Network Video Recorder

Version: V4.40.010 build 200430

Release Note

(2020-4-30)

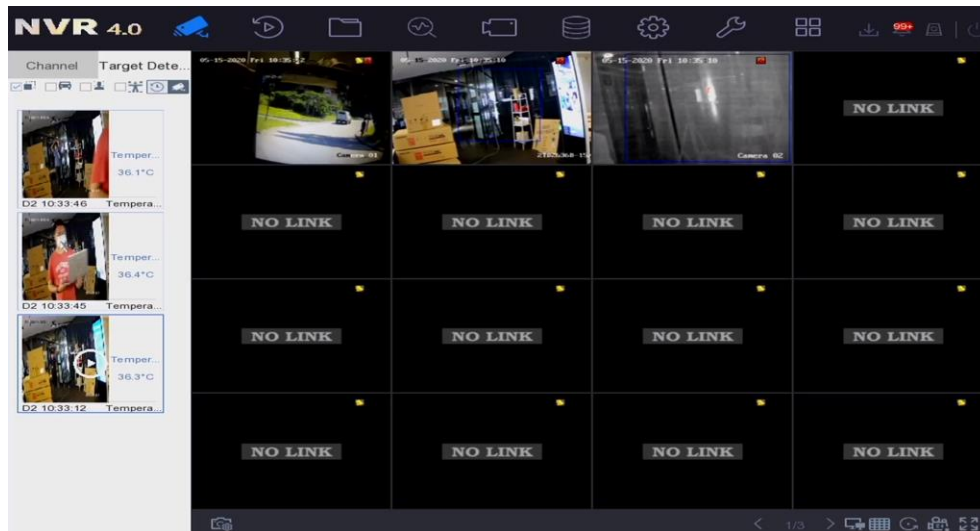
4. 【Support Hik-Connect / GuardingVision to scan NVR QR code to recover password】

1) Support local HC / GV scanning QR code and mailbox to recover password, Local GUI delete the recovery way of GUID and security issues; WEB still retain GUID, security issues and mailbox to recover password.

2) Only the NVR that has been bound to the HC / GV will display the option to scan the code to recover the password.

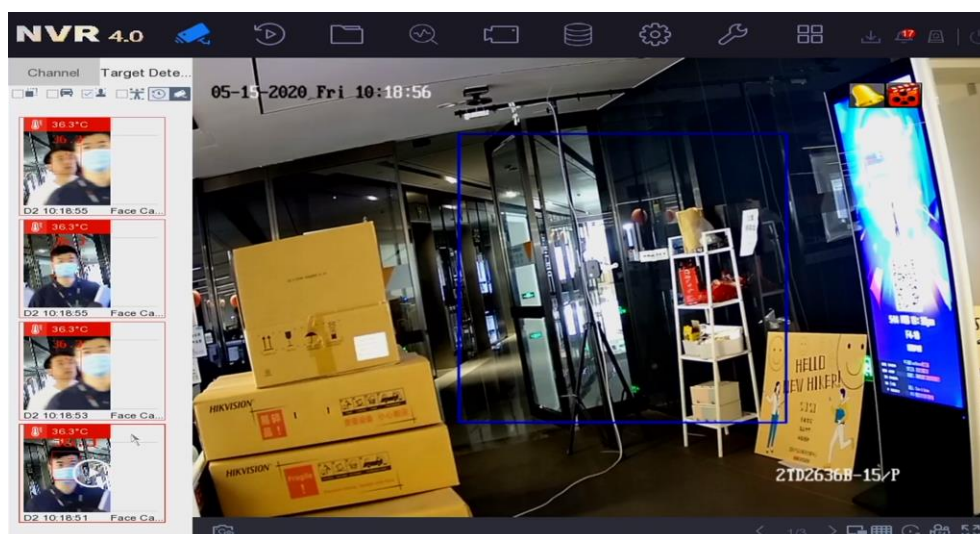
6. 【Support thermal camera temperature measurement alarm】

1) Support local target detection interface and 4200 to display real time temperature measurement alarm.

2) Support uploading pictures of visible light and thermal imaging to the platform software.

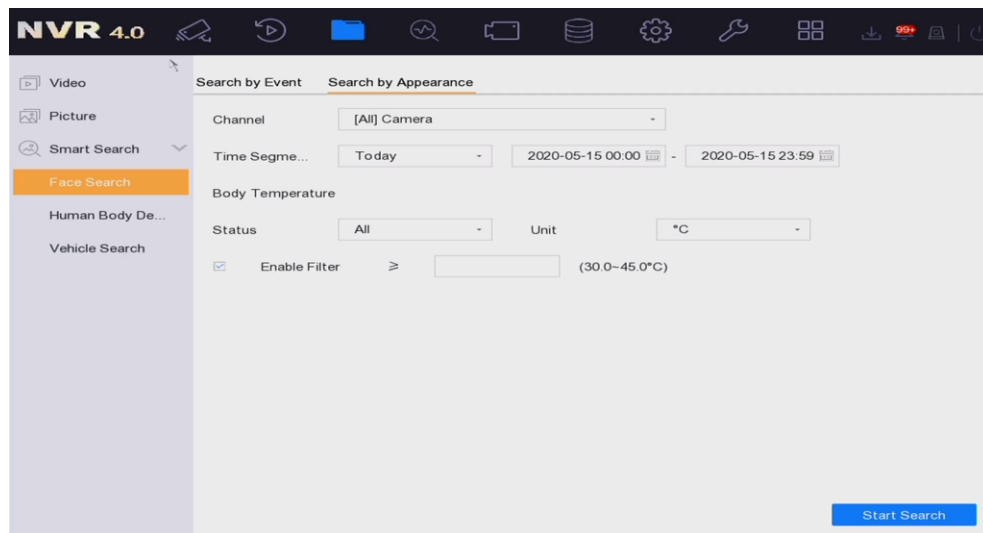
7. 【Support thermal camera face temperature alarm】

1) Support local target detection interface and 4200 to display real time face temperature alarm, abnormal temperature display red background, normal temperature display green background.

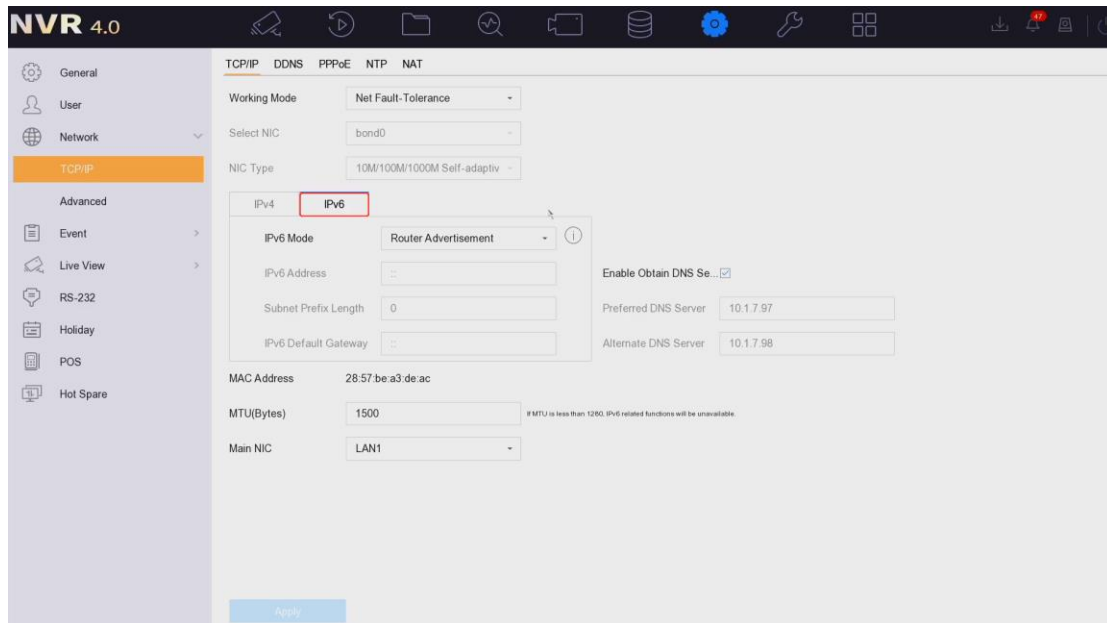
2) Support the voice announcement function of face temperature state linkage. NVR has two English pronunciations: abnormal temperature and normal temperature. Normal temperature is not linked by default, and abnormal temperature is linked by default.

3) Support local and 4200 to search face pictures according to body temperature status and temperature range, and support to display search results in specified temperature units.

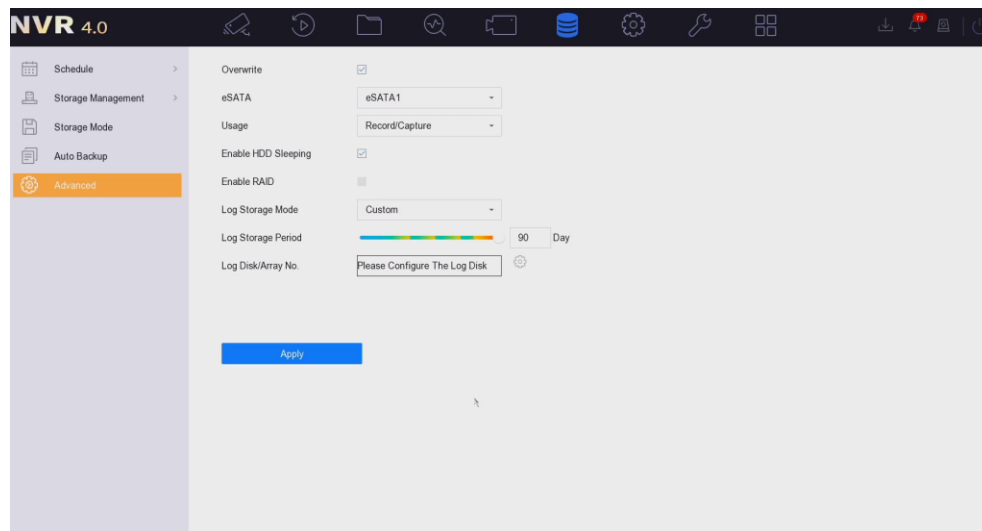
8. 【Support IPv6 network】

Support IPv6 network.
